**PUBLIC HEARING TO CONSIDER THE PROPOSED “LEV II” AND “CAP 2000”
AMENDMENTS TO THE CALIFORNIA EXHAUST AND EVAPORATIVE EMISSION
STANDARDS AND TEST PROCEDURES FOR PASSENGER CARS, LIGHT-DUTY
TRUCKS AND MEDIUM-DUTY VEHICLES, AND TO THE EVAPORATIVE
EMISSION REQUIREMENTS FOR HEAVY-DUTY VEHICLES**

Staff’s Suggested Changes to the Original Proposal

PRESENTED AT THE NOVEMBER 5, 1998 HEARING OF THE AIR RESOURCES BOARD

Figure 3A: Test Procedure for 2003 and Subsequent Hybrid Electric Vehicles

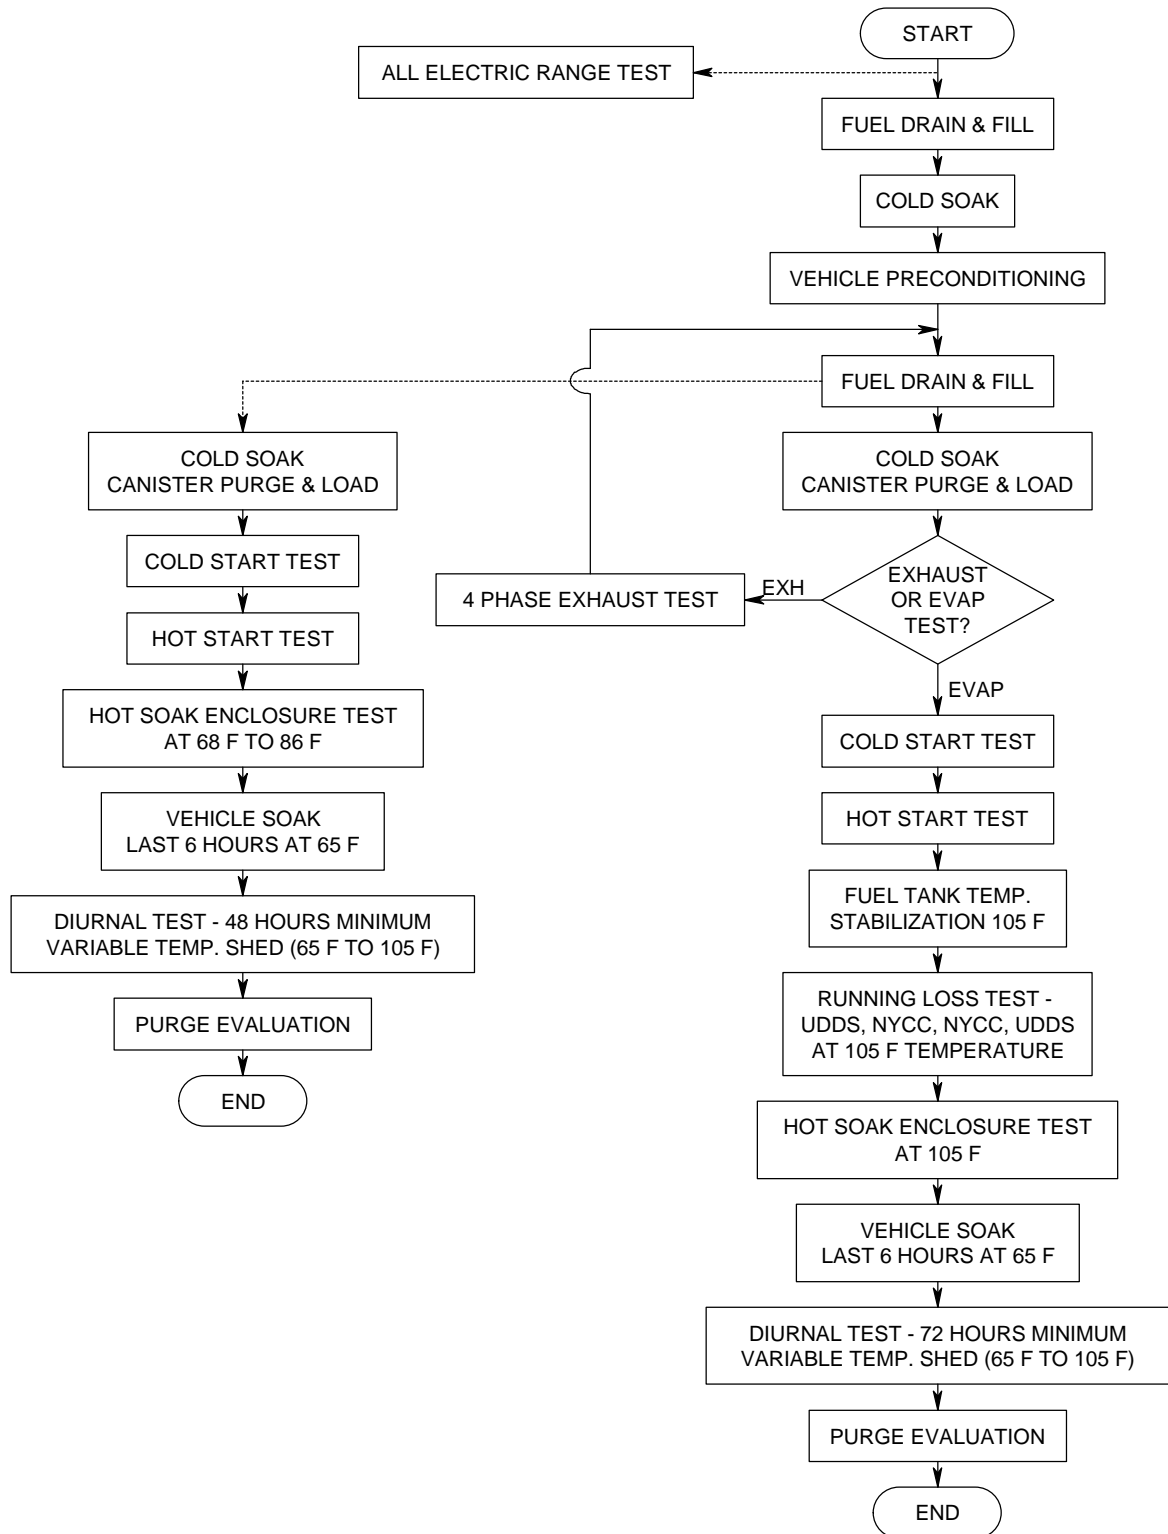
1.7.1 For hybrid electric vehicles, a four phase exhaust test shall be performed as shown in Figure 3A pursuant to the “California Zero-Emission and Hybrid Electric Vehicle Exhaust Emission Standards and Test Procedures for 2003 and Subsequent Model Passenger Cars, Light-Duty Trucks, and Medium-Duty Vehicles” as incorporated by reference herein. Following the four phase exhaust test, the test sequence shall repeat from step 1.3 of this section to conduct the evaporative test using the standard cold start test and hot start test (standard three phase test) without emission sampling. Battery state-of-charge setting prior to the standard three phase test shall be performed pursuant to section 6.1.6 of the “California Zero-Emission and Hybrid Electric Vehicle Exhaust Emission Standards and Test Procedures for 2003 and Subsequent Model Passenger Cars, Light-Duty Trucks, and Medium-Duty Vehicles” as incorporated by reference herein. Four phase exhaust testing may be performed in conjunction with evaporative testing as shown in Figure 3B with advance Executive Order approval if the manufacturer is able to provide data demonstrating compliance with evaporative testing using the standard three phase test.

This text would be added to retain evaporative emission testing stringency by separating the four phase hybrid electric vehicle exhaust emission test from the evaporative emission test that requires a three phase test.

Figure 3B: Test Procedure for 2003 and Subsequent Hybrid Electric Vehicles

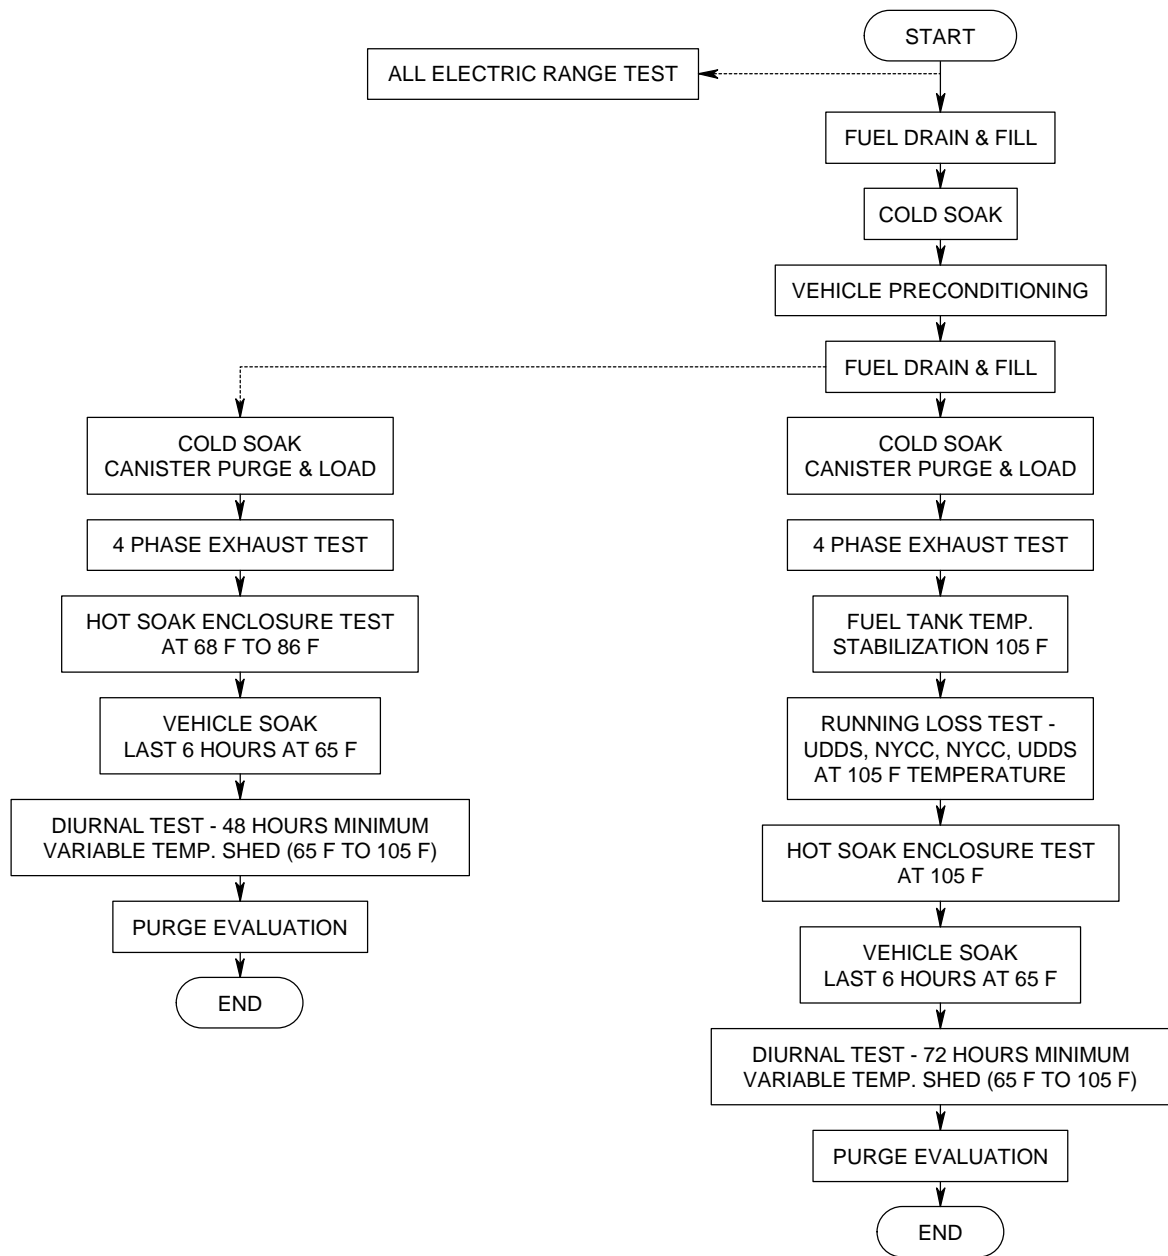
The test sequence shown in Figure 2 (Figure 3A or 3B for hybrid electric vehicles) describes the steps encountered as the vehicle undergoes the three-day diurnal sequence and the supplemental two-day diurnal sequence to determine conformity with the standards set forth. Methanol measurements may be omitted when methanol-fueled vehicles will not be tested in the evaporative enclosure. Ambient temperature levels encountered by the test vehicle throughout the entire duration of this test sequence shall not be less than 68°F nor more than 86°F, unless otherwise specified. The temperatures monitored during testing shall be representative of those experienced by the test vehicle. The test vehicle shall be approximately level during all phases of the test sequence to prevent abnormal fuel distribution. The temperature tolerance of a soak period may be waived for up to 10 minutes to allow purging of the enclosure or transporting the vehicle into the enclosure.

The three-day diurnal test sequence shown in Figure 2 (and Figure 3A or 3B for hybrid electric vehicles) is briefly described as follows:

The supplemental two-day diurnal sequence in Figure 2 (and Figure 3A or 3B for hybrid electric vehicles) shall be conducted according to the steps described in 1.1 through 1.4, 1.6, 1.7, followed by 1.10 through 1.12 of this paragraph except that the ambient temperature of the hot soak test is conducted at an ambient temperature between 68°F and 86°F at all times and that the diurnal test will consist of a two-day test.
